10.4 Other Features of Steam and Power Conversion

The information in this section of the reference ABWR DCD, including all subsections, tables, and figures is incorporated by reference with the following departures and supplements.

Figure 10.4-1 Main Condenser Evacuation System

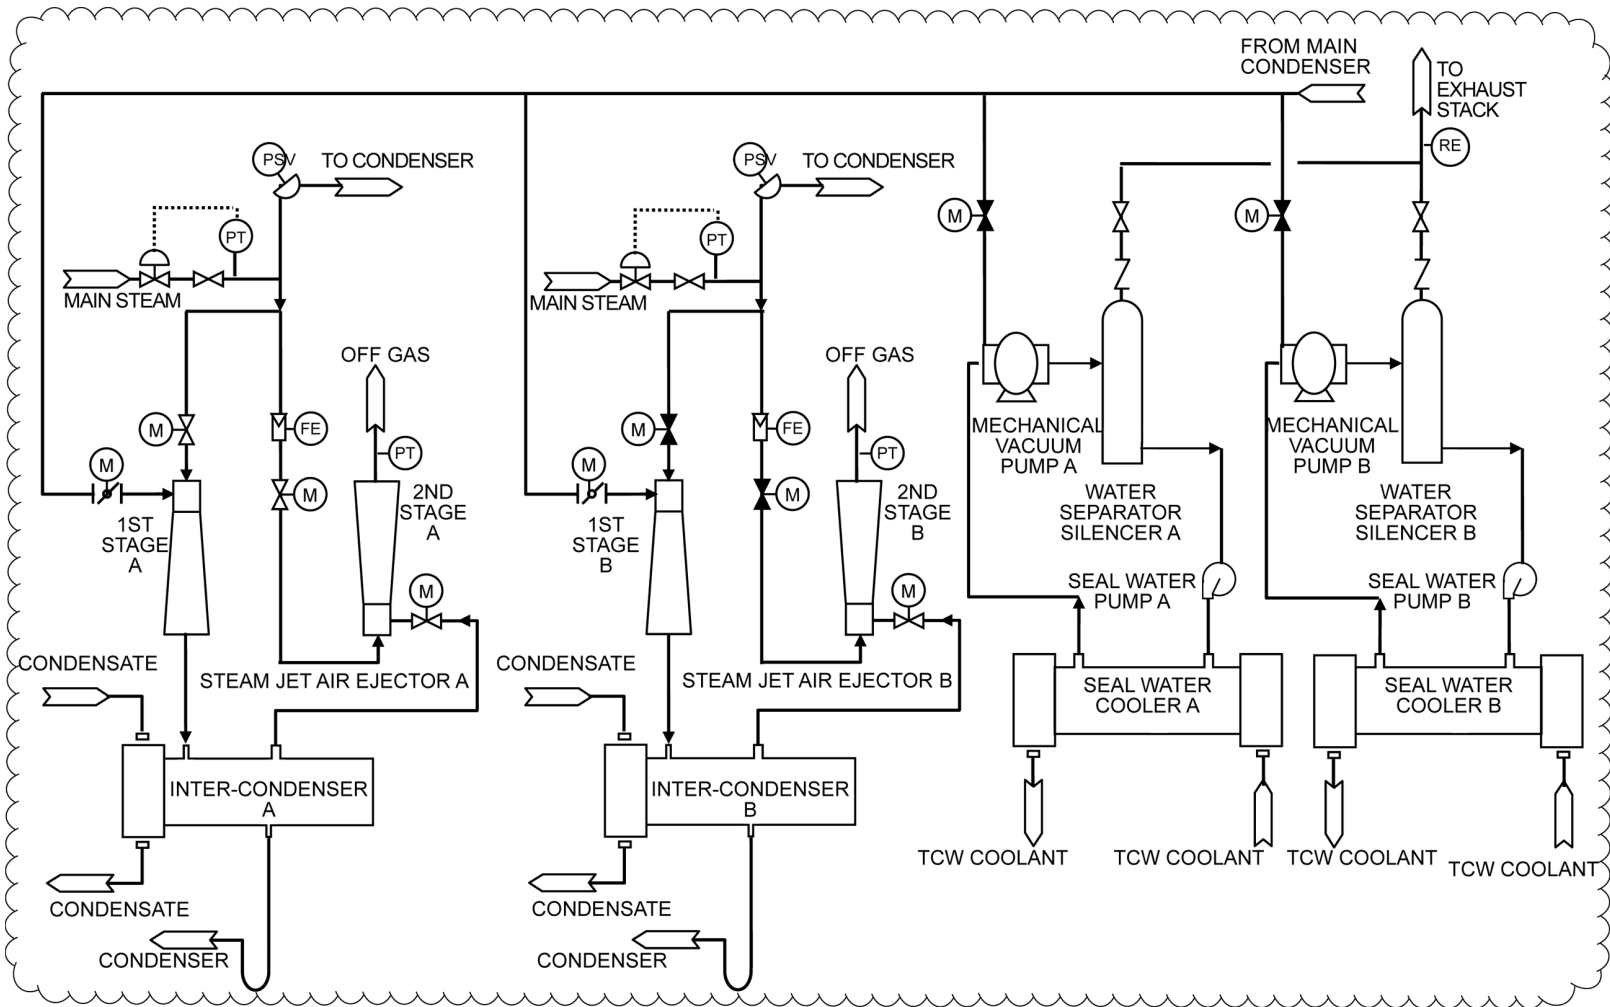
STP DEP 10.4-3 (Table 10.4-2, Figure 10.4-1)

The MCES (figure 10.4-1) consists of two 100%-capacity, double stage, steam jet air ejector (SJAE) units (complete with ~~intercondenser~~ intercondensers) for power plant operation, and ~~a two, 100% mechanical vacuum pump pumps~~ for use during startup. The last stage of the SJAE is a noncondensing stage. One SJAE unit is normally in operation and the other is on standby.

Figure 10.4-3 Circulating Water System

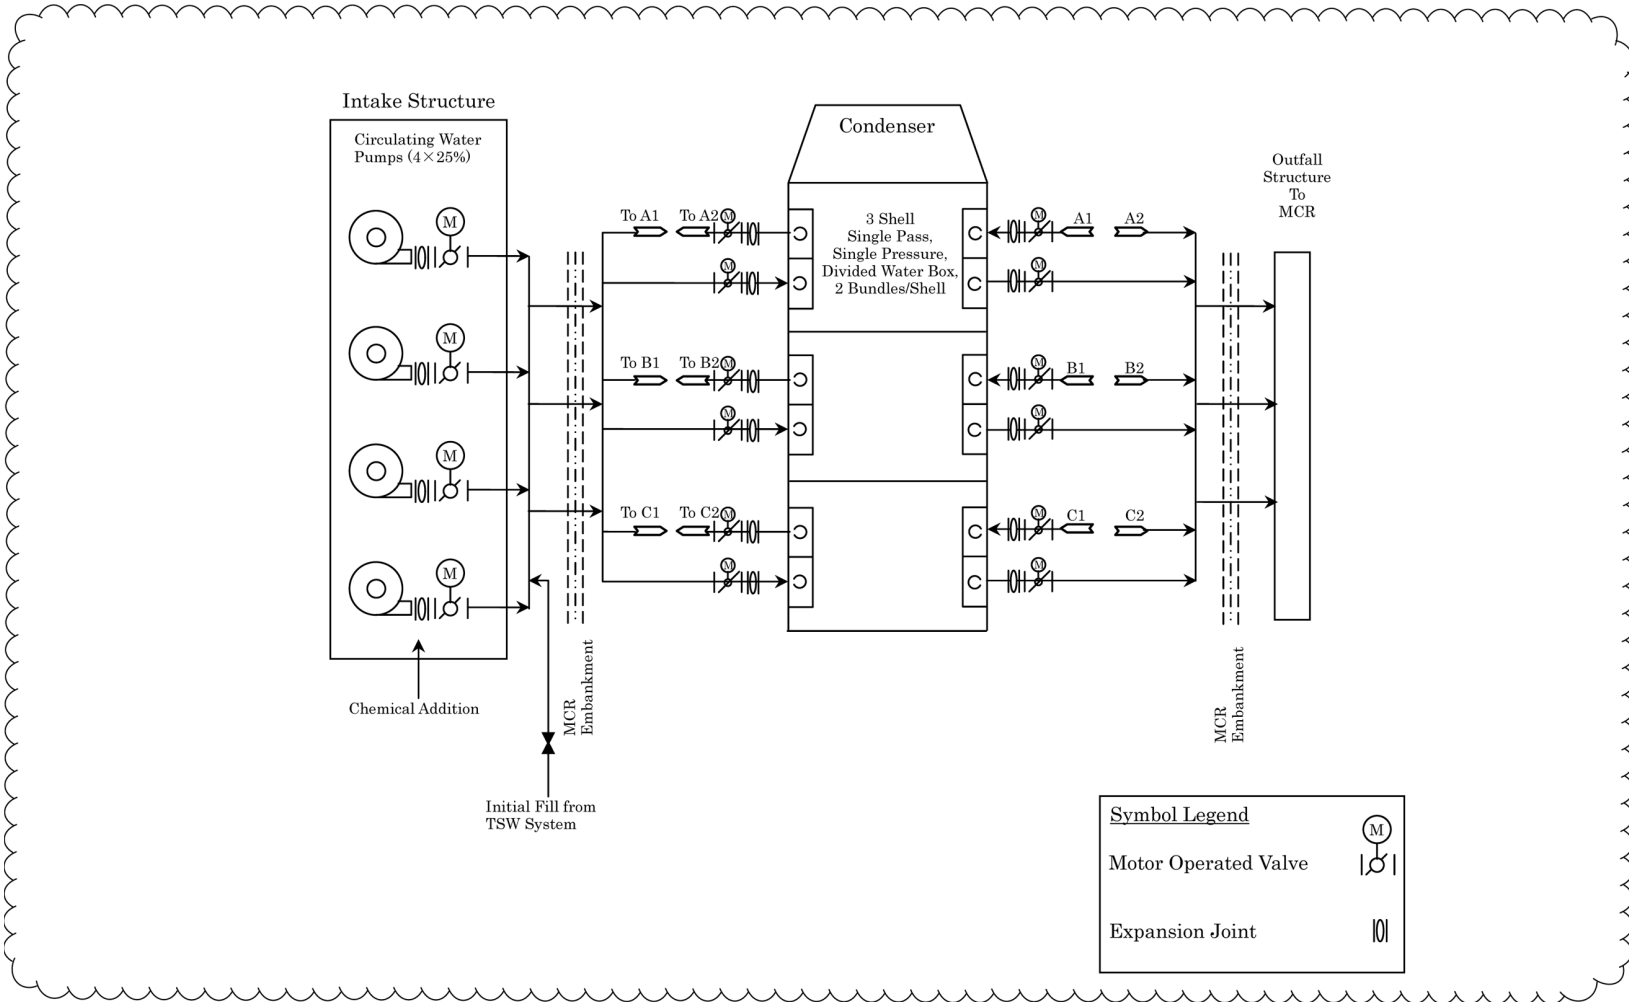
STP DEP 10.4-2 (Table 10.4-1, Table 10.4-3, Figure 10.4-3)

The Circulating Water System (Figure 10.4-3) consists of the following components: (1) ~~screen house~~ intake structure and intake screens, pumps, (2) condenser water boxes and piping and valves, (3) tube side of the main condenser, (4) water box fill and drain subsystem, and (5) related support facilities such as for system water treatment, inventory blowdown and general maintenance.

The cooling water is circulated by ~~at least three~~ four 25% capacity fixed speed motor-driven pumps per unit.

Four 25% capacity fixed speed circulating water pumps per unit discharge into a common header shown in Figure 10.4-3. The discharge of each pump is fitted with a motor operated butterfly valve. The circulating water is pumped through the main condenser and back to the MCR via a discharge outfall at a nominal rate of 272,550 m³/h per unit. To provide capability for condenser waterbox isolation, isolation valves are located on the circulating water inlet and outlet lines.

Figure 10.4-5 Condensate System

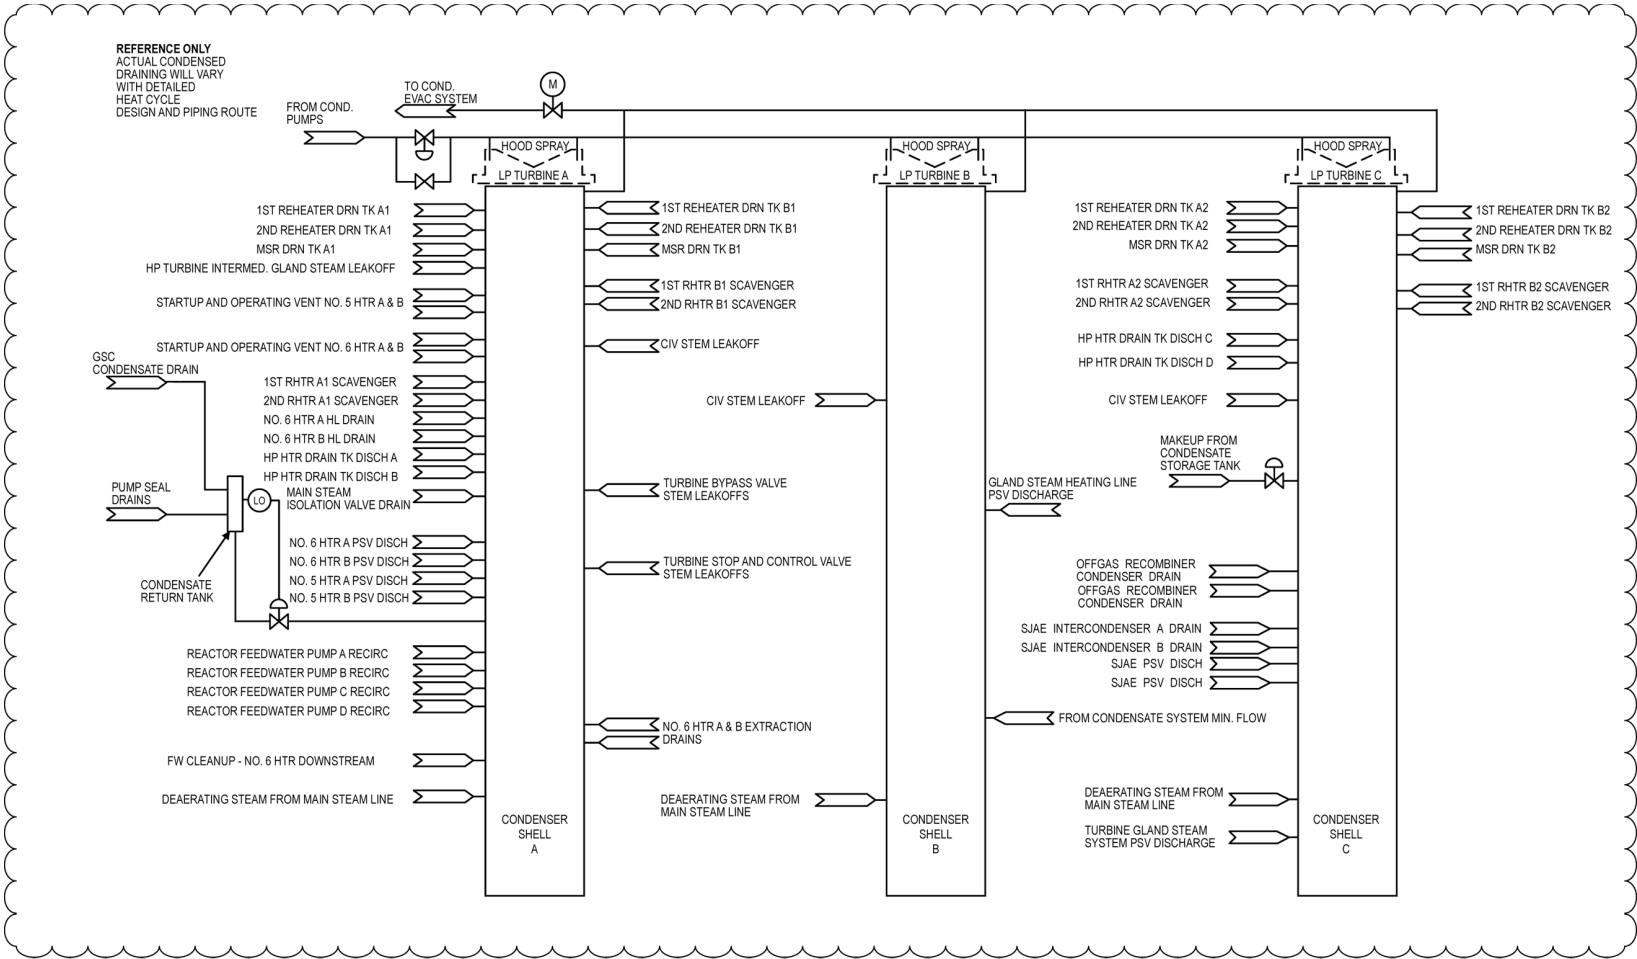
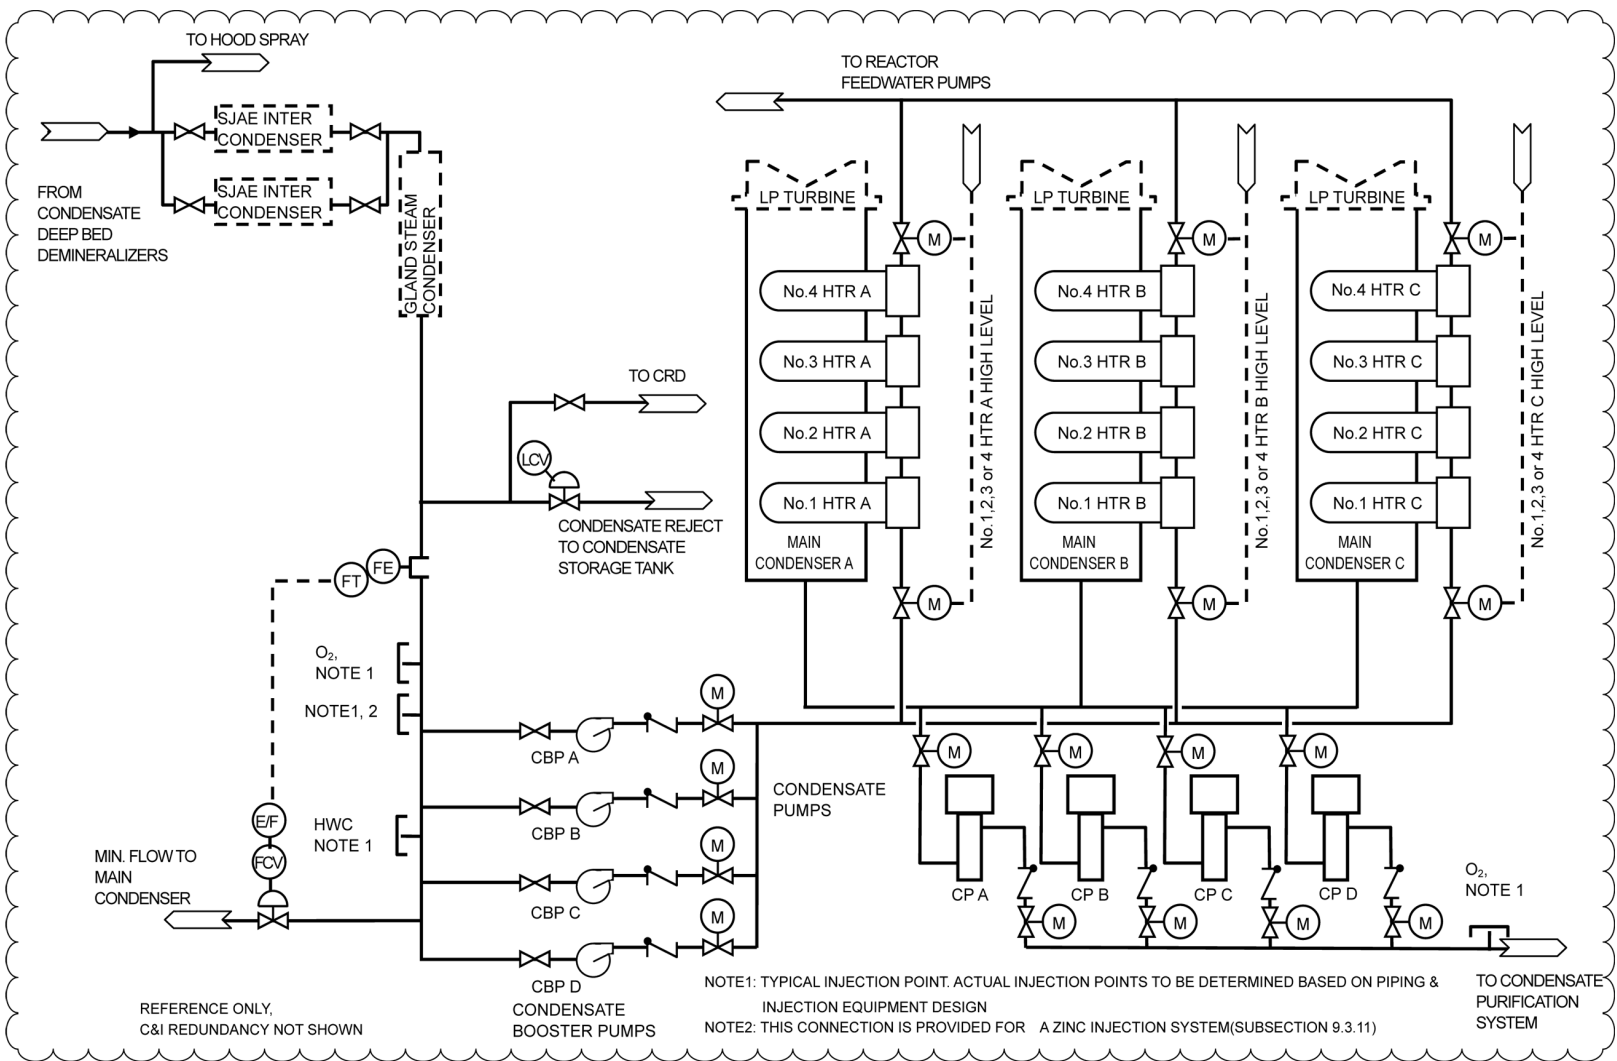
STD DEP 9.2-3 (Figure 10.4-5)

STD DEP 10.4-5 (Tables 10.4-4, 10.4-5 and 10.4-6, Figures 10.4-5, 10.4-6, 10.4-7, and 10.4-8)

The Condensate and Feedwater System (Figures 10.4-5 and 10.4-6) consists of the piping, valves, pumps, heat exchangers, controls and instrumentation, and the associated equipment and subsystems which supply the reactor with heated feedwater in a closed steam cycle utilizing regenerative feedwater heating. The system described in this subsection extends from the main condenser outlet to (but not including) the seismic interface restraint outside of containment. The remainder of the system, extending from the restraint to the reactor, is described in Chapter 5. Turbine cycle steam is utilized for a total of six stages of closed feedwater heating. The drains from each stage of the low-pressure feedwater heaters are cascaded through successively lower pressure feedwater heaters except the lowest and second lowest pressure feedwater heaters which drain to the low pressure heater drain tanks for each string. The drains from each low pressure heater drain tank flow into the external drain coolers of each lowest pressure feedwater heater and finally to the main condenser. The high pressure heater drains are pumped backward to the reactor feedwater pumps suction. The cycle extraction steam, drains and vents systems are illustrated in Figures 10.4-7 and 10.4-8.

The CFS consists of four ~~33-50%~~ 33% capacity condensate pumps (three normally operating and one on automatic standby), four 33% capacity condensate booster pumps, (three normally operating and one on automatic standby). ~~three normally operated 33-65%~~ four 33% capacity reactor feedwater pumps (three normally operating, one on automatic standby), four stages of low-pressure feedwater heaters, and two stages of high- pressure feedwater heaters, piping, valves, and instrumentation. The condensate pumps take suction from the condenser hotwell and discharge the deaerated condensate into one common header which feeds the condensate filter/demineralizers. Downstream of the condensate demineralizers, the condensate is taken by a single header and flows ~~in parallel through five~~ through the auxiliary condenser/coolers, one gland steam exhauster condenser, and two sets of SJAE condensers, ~~offgas recombiner condenser (coolers).~~ The condensate then branches into three parallel strings of low pressure feedwater heaters. Each string

Figure 10.4-6 Feedwater System

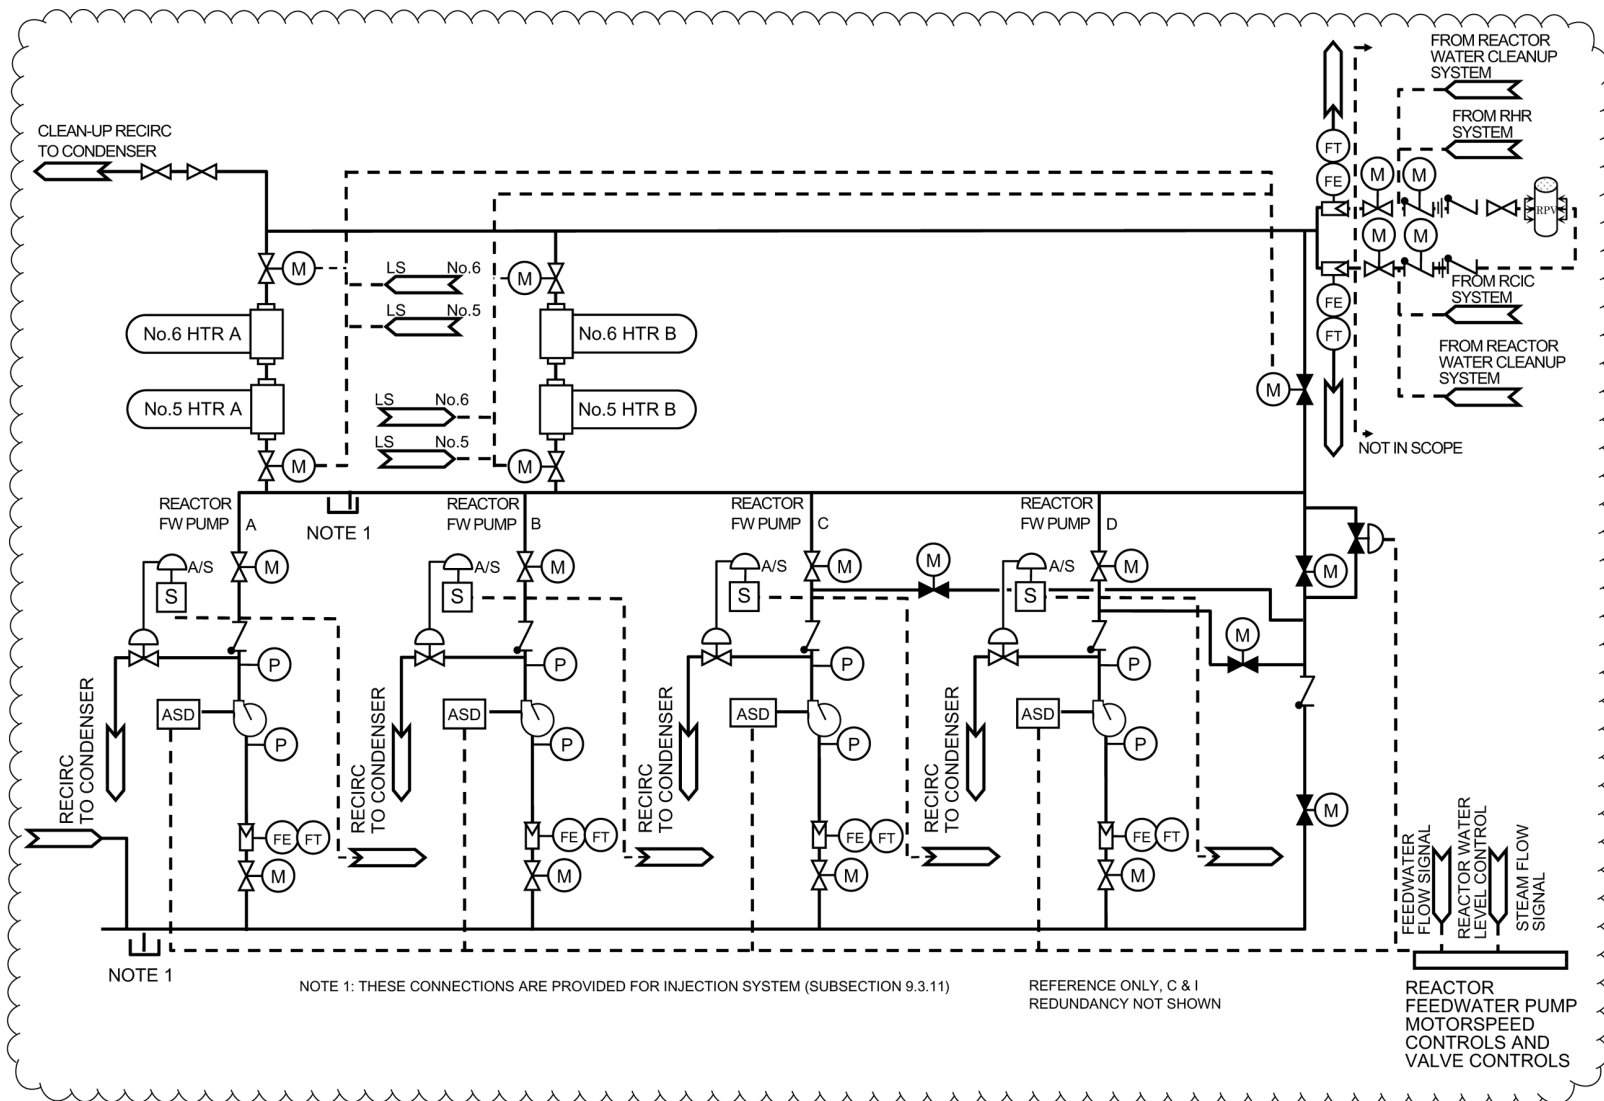
Reactor Feedwater Pumps—~~Three~~ Four identical and independent ~~33–65%~~ 33% capacity reactor feedwater pumps (RFP) are provided. ~~The~~ Three pumps normally manually operate in parallel and discharge to the high-pressure feedwater heaters. The pumps take suction downstream of the last stage low-pressure feedwater heaters and discharge through the high-pressure feedwater heaters. Each pump is driven by an adjustable speed drive.
